Title of Change:	ASPM27 Marking updating
Effective date:	20 Dec 2021
Contact information:	Contact your local onsemi Sales Office or Peter.Lee@onsemi.com
Type of notification:	This Product Bulletin is for notification purposes only. onsemi will proceed with implementation of this change upon publication of this Product Bulletin.
Change Category:	added version & current rate in marking section due to customer requesting.
Change Sub-Category(s):	Datasheet/Product Doc change

MARKING DIAGRAM

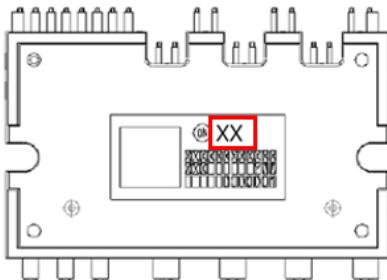
To differentiate between the various versions of ASPM27 products, a top marking change will be implemented. The top marking change will not impact form, fit or function of product(s).

PKG, Ver	OPNs	New marking spec	Meaning
ASPM27-V2	NFVA33065L32	23	Version 2, Current: 30A
ASPM27-V3	NFVA33065L42	33	Version 3, Current: 30A
ASPM27-V2	NFVA35065L32	25	Version 2, Current: 50A
ASPM27-V3	NFVA36065L42	36	Version 3, Current: 60A
ASPM27-V2	NFVA34065L32	24	Version 2, Current: 40A
ASPM27-V3	NFVA35065L42	35	Version 3, Current: 50A
ASPM27-V2	NFVA33065L32-Z007	23	Version 2, Current: 30A
ASPM27-V2	NFVA35065L32-Z007	25	Version 2, Current: 50A

ON	= ON Semiconductor Logo
XX	= Version, Current Rate
XXXXXXXXXXXX	= Specific Device Code
XXX	= Lot Number
Y	= Year
WW	= Work Week
000001	= Serial Number
